HISTORIC AND DESIGN REVIEW COMMISSION February 07, 2018

HDRC CASE NO: ADDRESS: LEGAL DESCRIPTION: ZONING: CITY COUNCIL DIST.: DISTRICT: APPLICANT: OWNER: TYPE OF WORK: APPLICATION RECEIVED:	 2017-588 814 BURNET ST NCB 549 (814 BURNET SUB'D {IDZ}), BLOCK 9 LOT 18 IDZ H 2 Dignowity Hill Historic District Felix Ziga/Ziga Architecture Studio Poma Properties, LLC Construction of four, two story, single family residential structures January 19, 2018
APPLICATION RECEIVED:	January 19, 2018
60-DAY REVIEW:	March 20, 2018

The applicant is requesting a Certificate of Appropriateness for approval to construct four, two story residential structures on the vacant lot at 814 Burnet.

NEW SINGLE FAMILY RESIDENCE 814 BURNET ST. - LOT 19, SAN ANTONIO, TX 78202

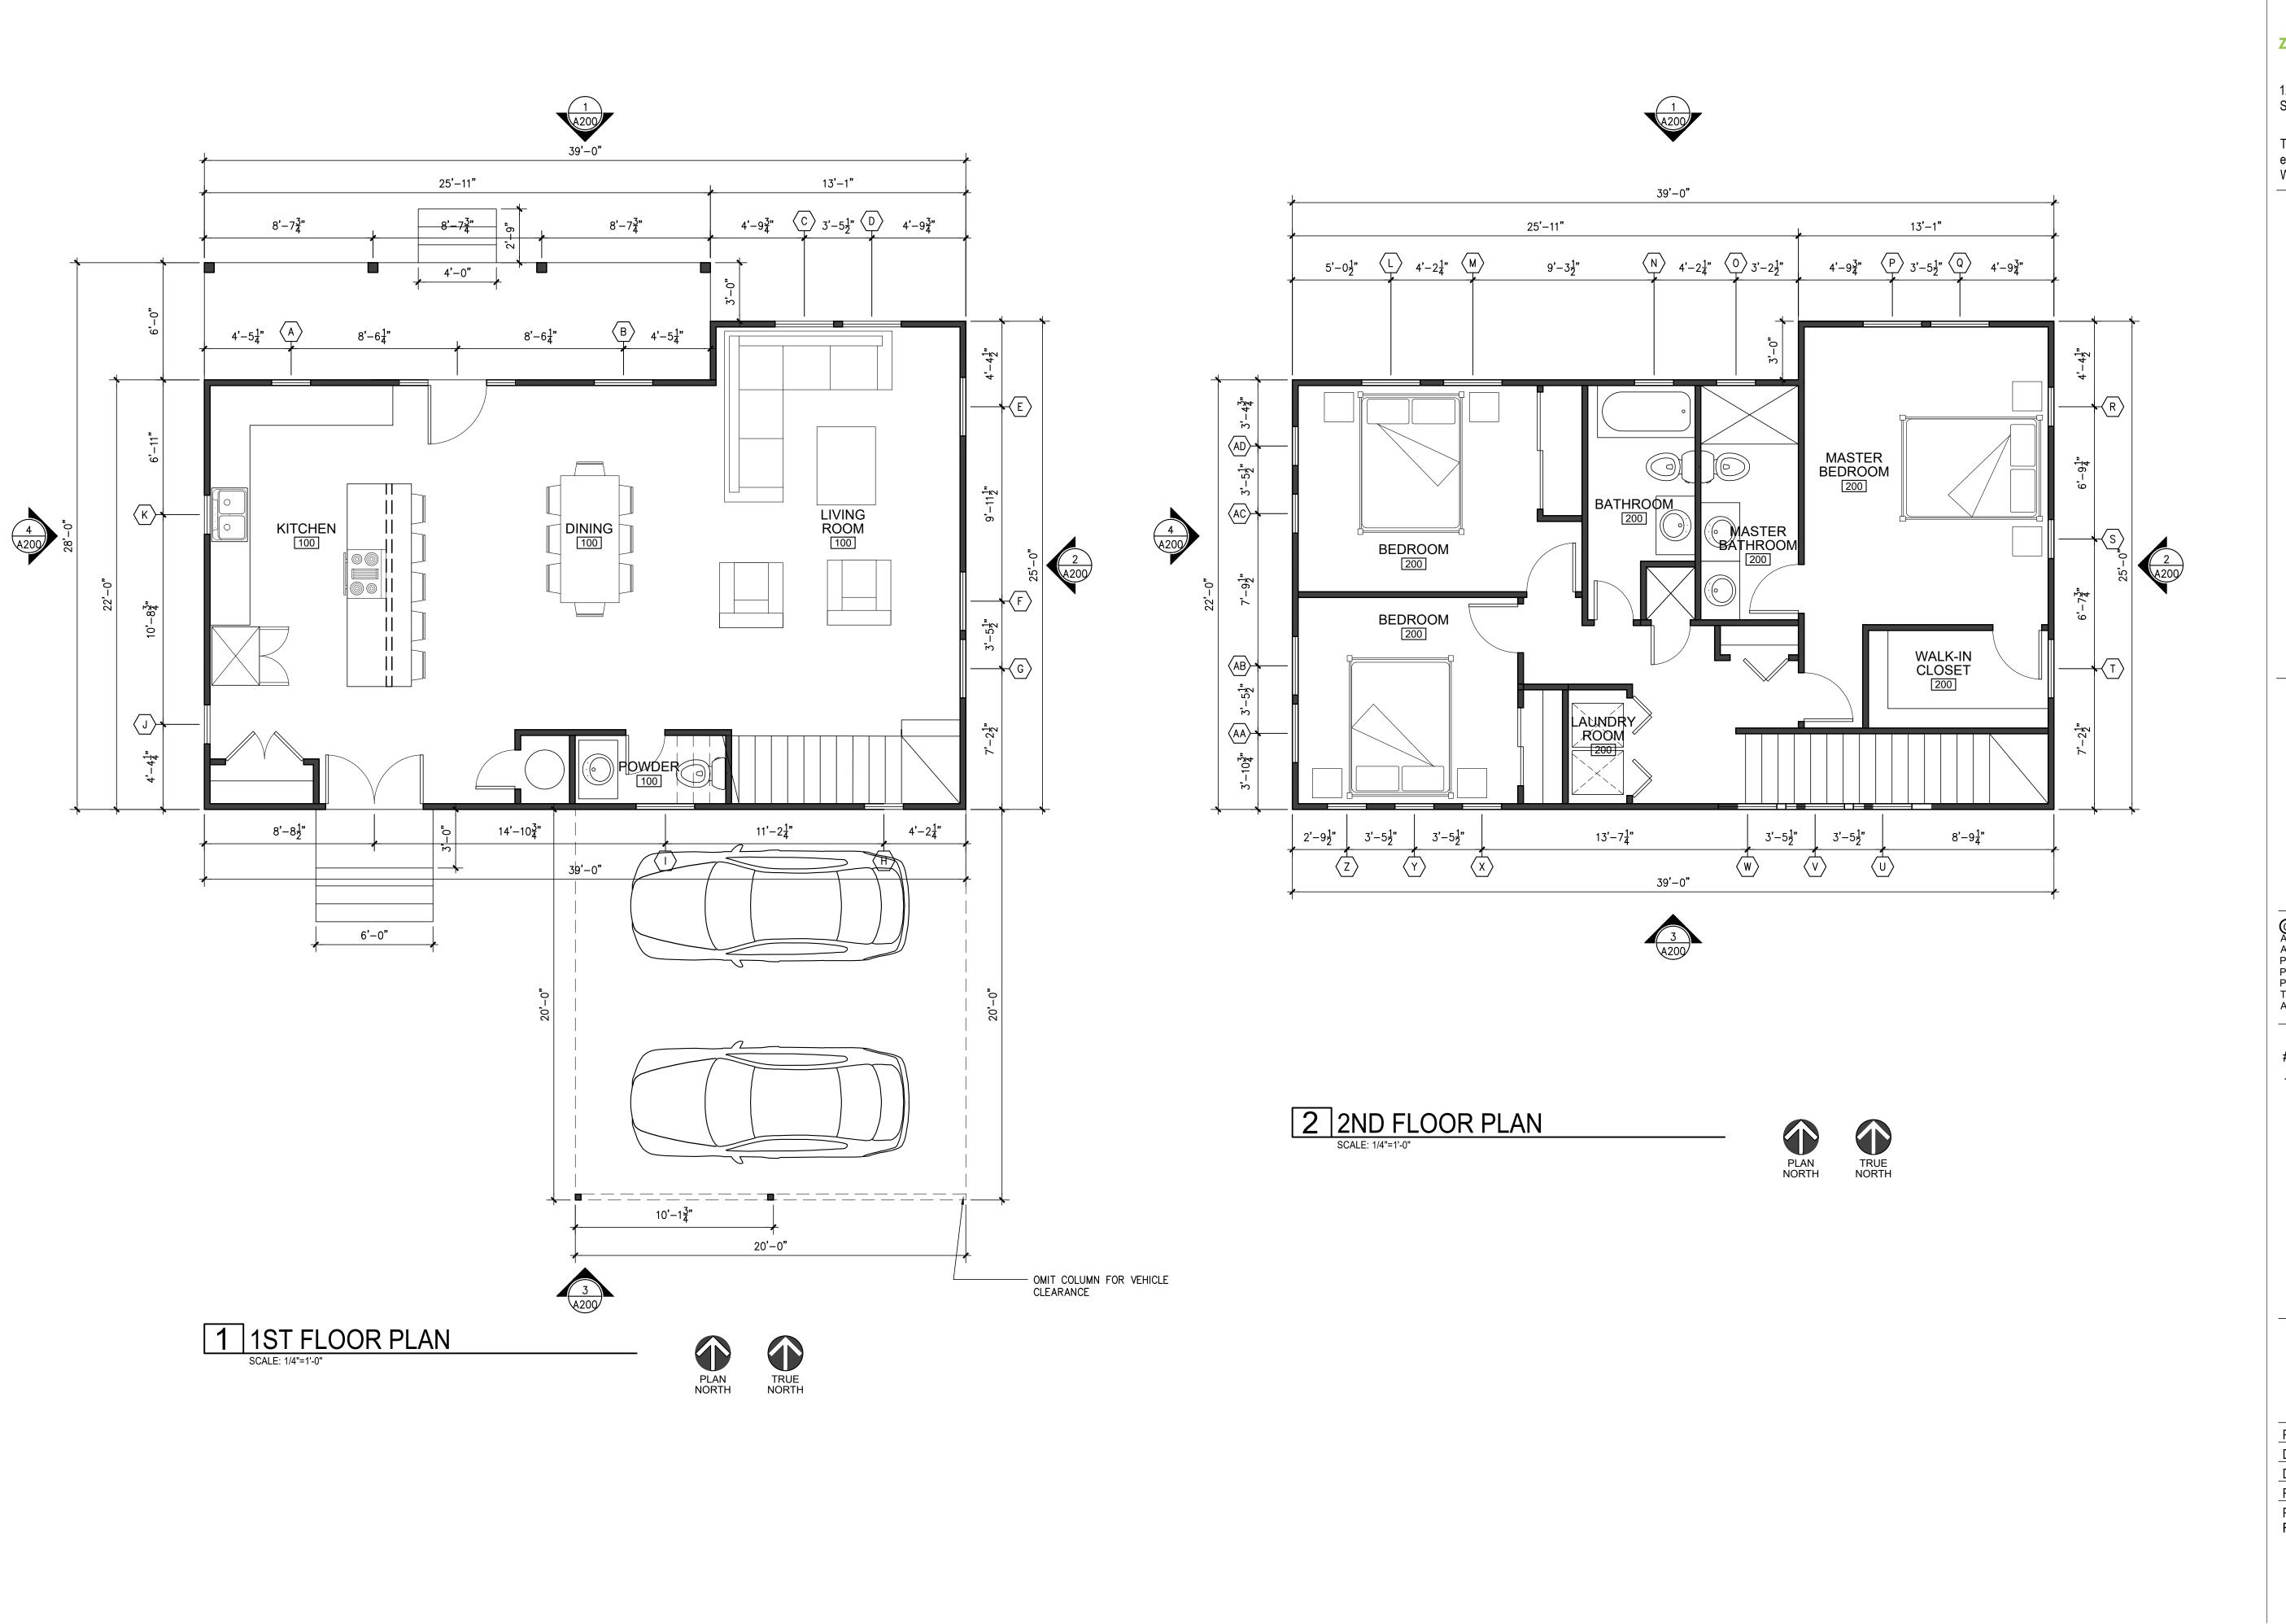
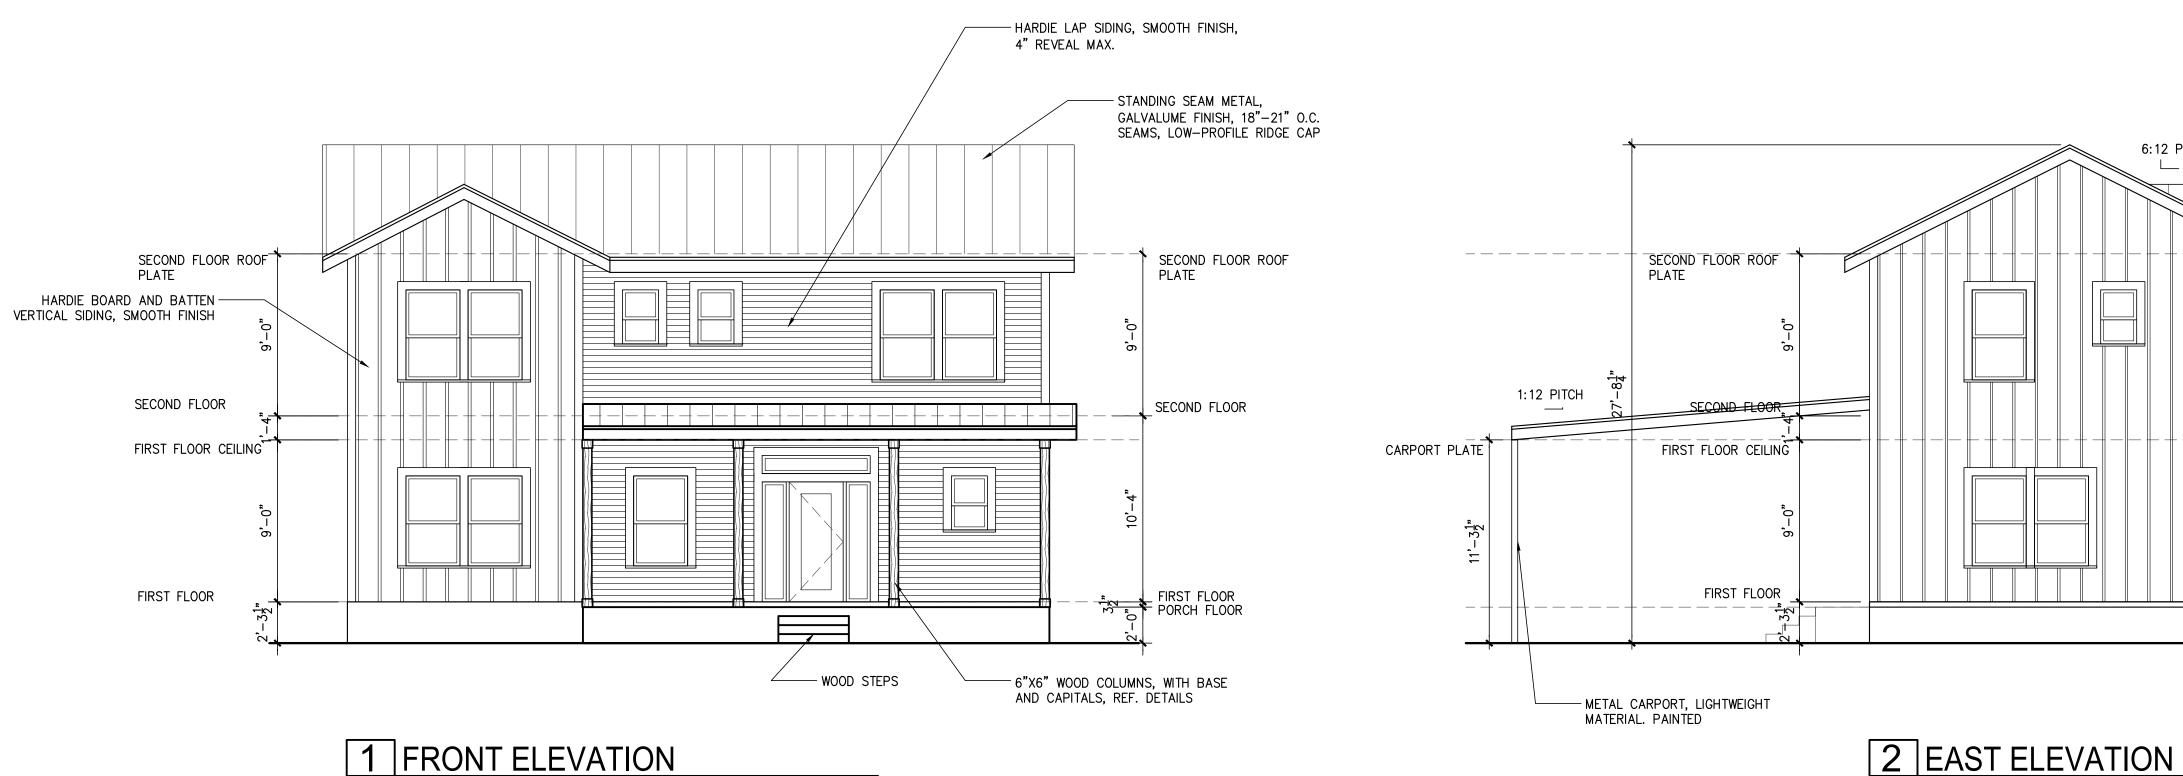
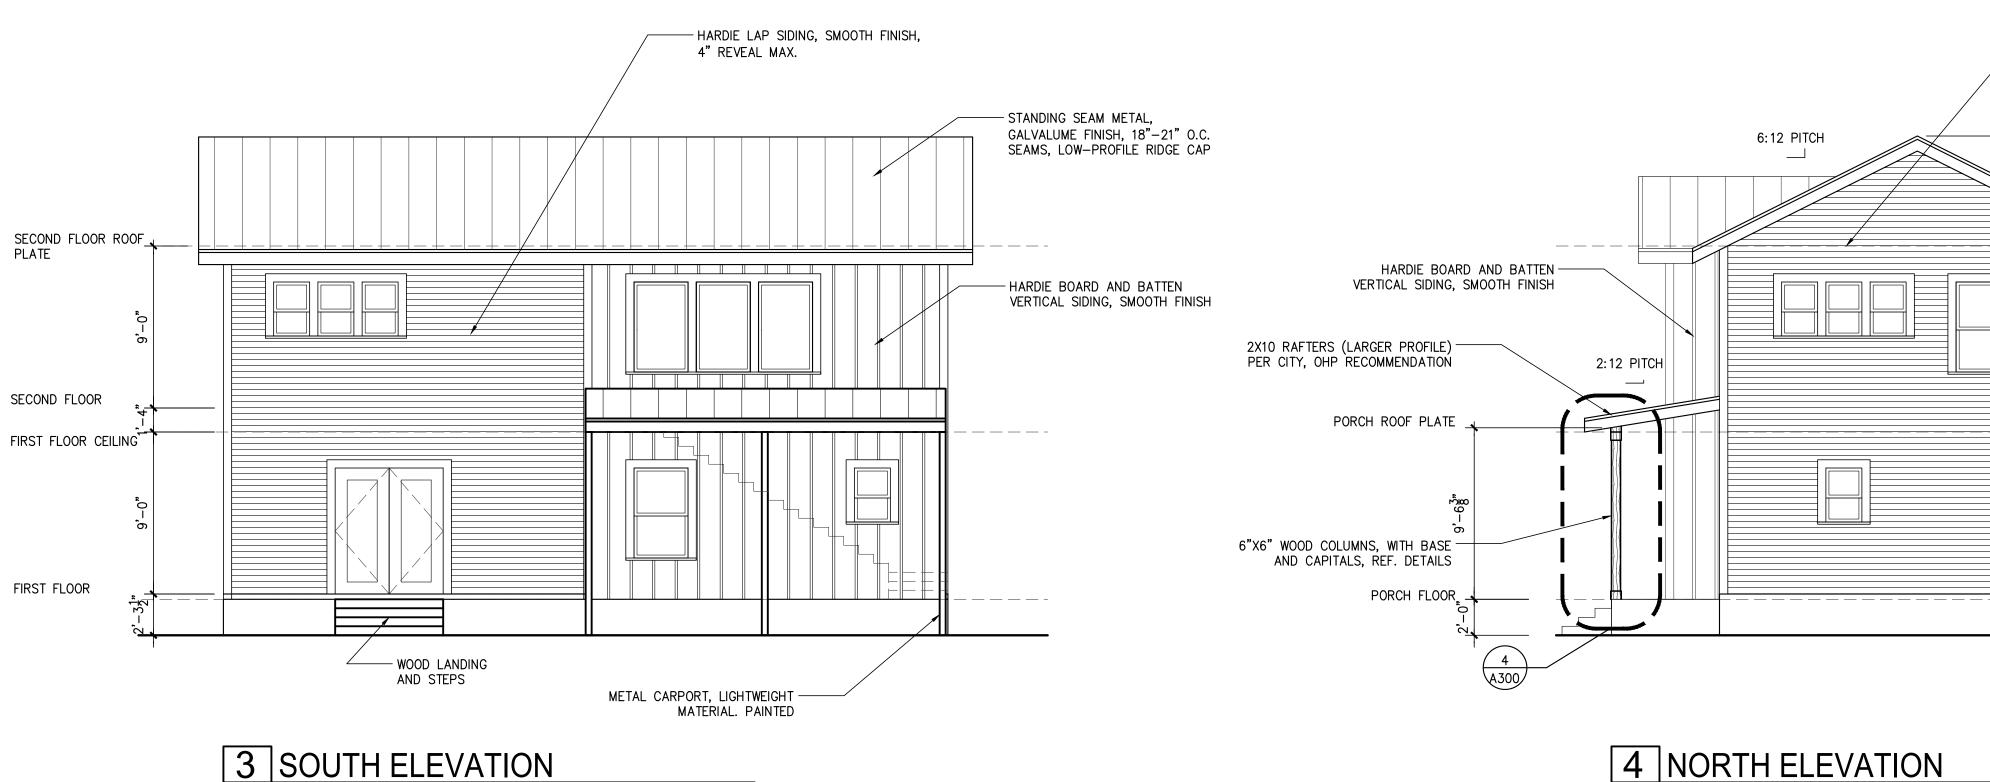
- n. ARCHITECTURAL DETAILS –Folk Victorian structures rely heavily on the relationship between front protruding window bays, side gables and inset porches. The front facing gable should extend to the top of the cross ridge line to present equal heights for both portions of the L plan. This has not been accomplished in unit 1. Additionally, porches on Folk Victorian structures are recessed behind the massing of protruding bays. As proposed, the applicant has proposed a porch that extends forward from the massing of the new construction. This is not architecturally appropriate. The front bay and gable should extend to the front of the porch massing.

- vii. That the structure proposed on lot 19 feature a front bay and gable that protrude further in order to meet to the

front of the front porch massing.
